RE: Florida Power & Light/St. Lucie Unit 1 Final Compliance with EA-12-051 Order Modifying Licenses with Regard to Reliable Spent Fuel Pool Instrumentation

1. St. Lucie Plant, Unit 1 Order EA-12-051 Compliance Requirements Summary
2. St. Lucie Plant SFPI RAI Replies

**ST. LUCIE PLANT, UNTS 1 AND 2- INTERIM STAFF EVALUATION AND
REQUEST FOR ADDITIONAL INFORMATION REGARDING THE OVERALL
INTEGRATED PLAN FOR IMPLEMENTATION OF ORDER EA-12-051,
RELIABLE SPENT FUEL POOL INSTRUMENTATION**

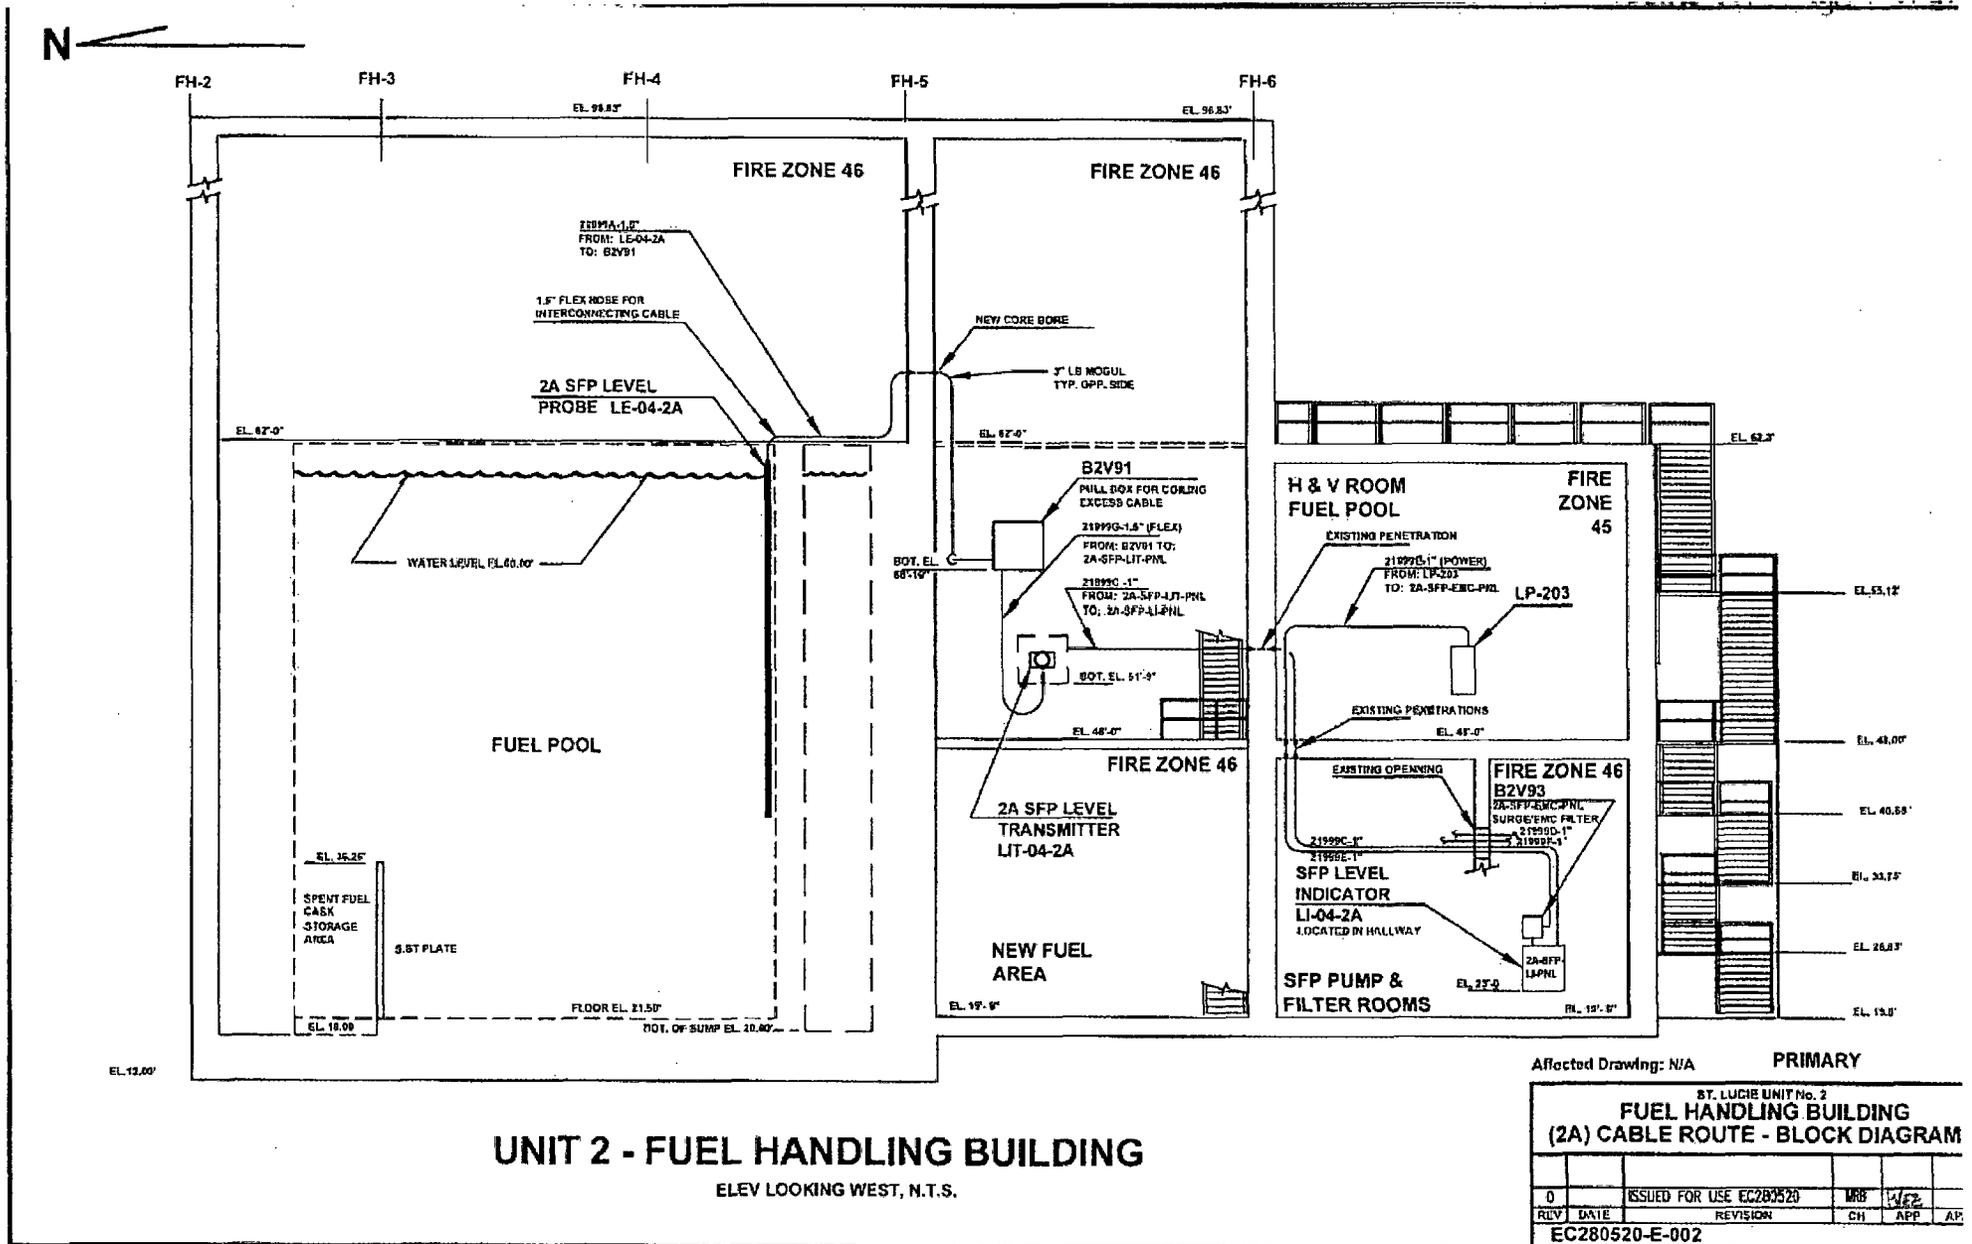
For the reasons described above, the proposed location for these transmitters on the 48' elevation in the new fuel storage area is deemed acceptable. In the worst postulated case, the transmitter output will be unavailable for a period of approximately 4 minutes out of the total 7 day mission duration and will self-recover without operator or maintenance interaction. Due to the volume of the spent fuel pool and the various postulated drain down/boil-off scenarios, it is extremely unlikely that significant changes in SFP level will occur during this short interruption of indication. Also, the transmitter began to respond erratically just prior to the ramp down to 140°F meaning that the components were at the 170°F elevated temperature for close to 24 hours allowing them to "soak" at the high temperature. With the short excursion time of approximately 4 minutes above 140°F , it is unlikely the transmitter will even enter into an erratic behavior period. The NEMA 4X and electronics IP67 certified enclosures will likely act as heat sinks and therefore insulate the actual electronics during this brief period.

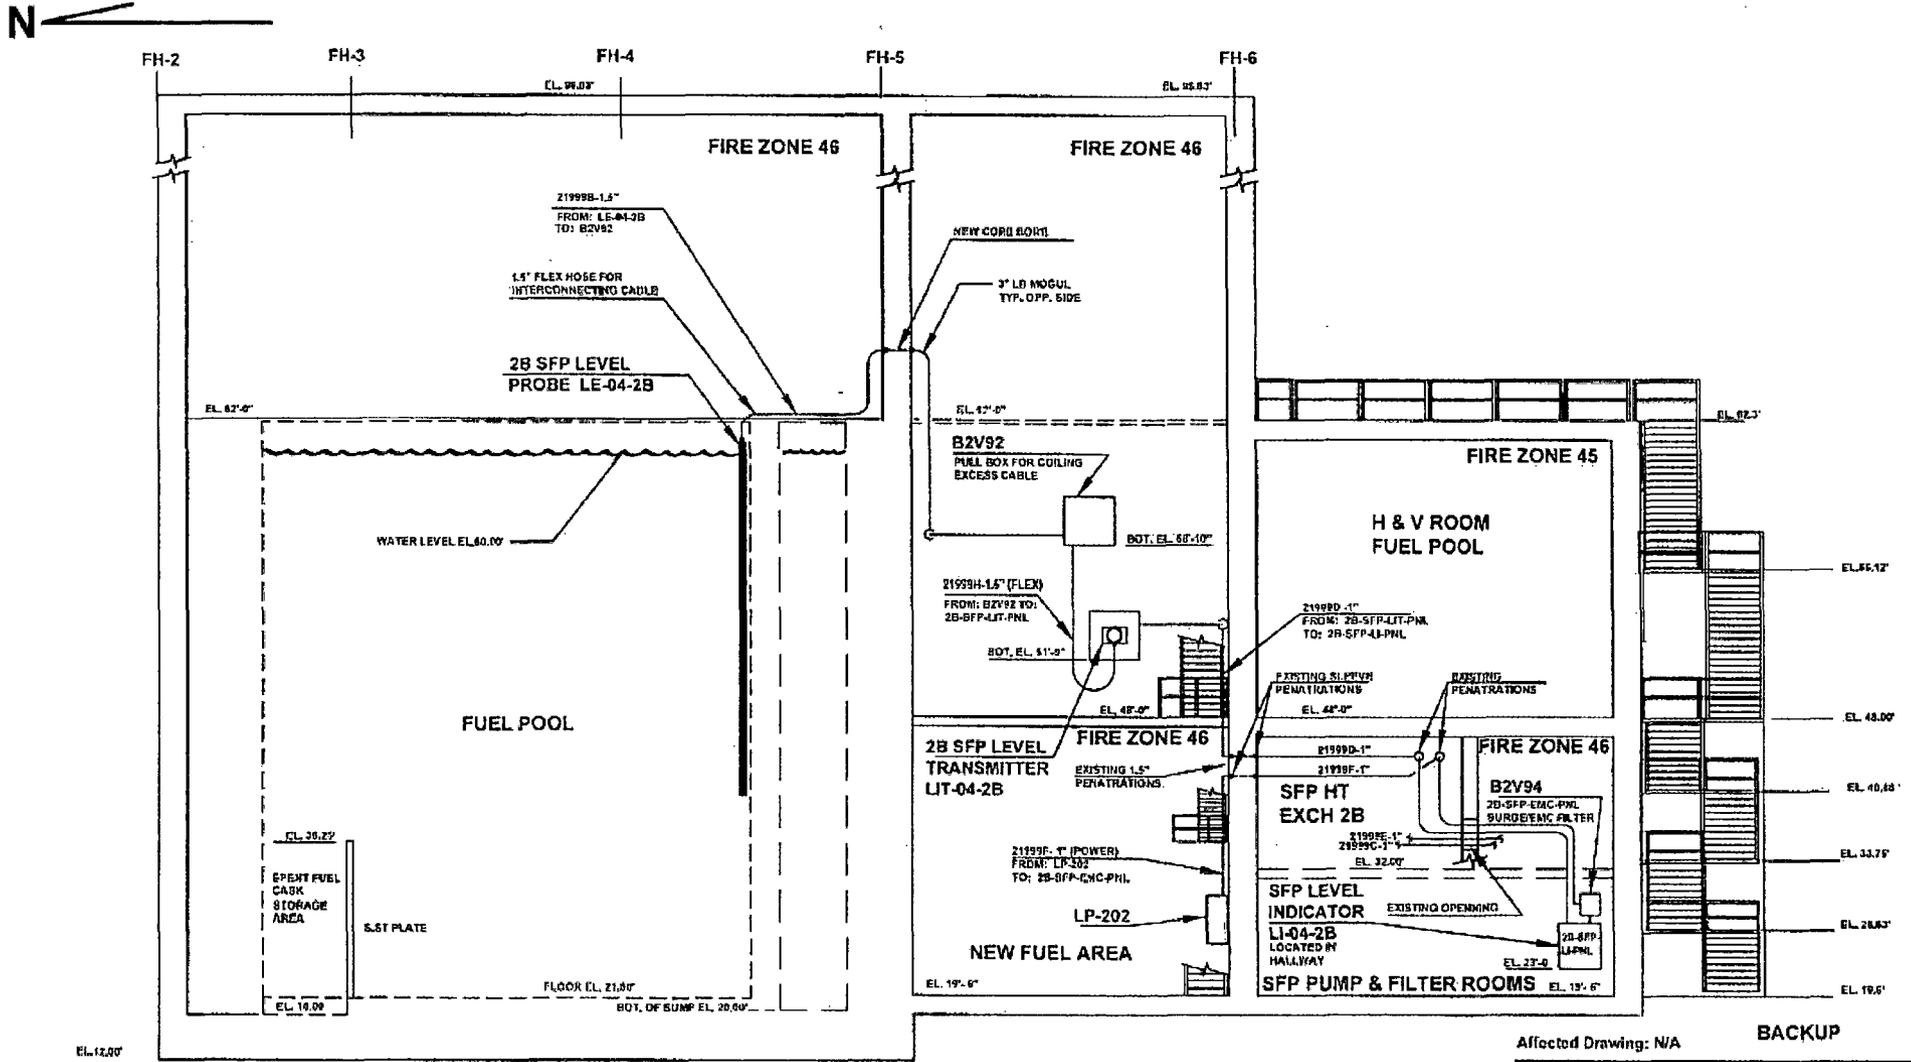
A similar evaluation relates to the transmitter housing regarding the 100% humidity requirement. The short term duration excursions above 95% are coupled with oscillations to levels significantly below the publish limit. The transmitter housing's EN 60529 IP67 Certification, has confirmed satisfactory performance at a submergence of 1 meter for at least 30 minutes. NEMA 4X is defined as being watertight and able to withstand at least 65 GPM of water from a 1-in. nozzle delivered from a distance not less than 10 ft. for 5 min. Therefore, based on duration and defense in depth, the enclosure is deemed satisfactory to mitigate the postulated humidity in the area.
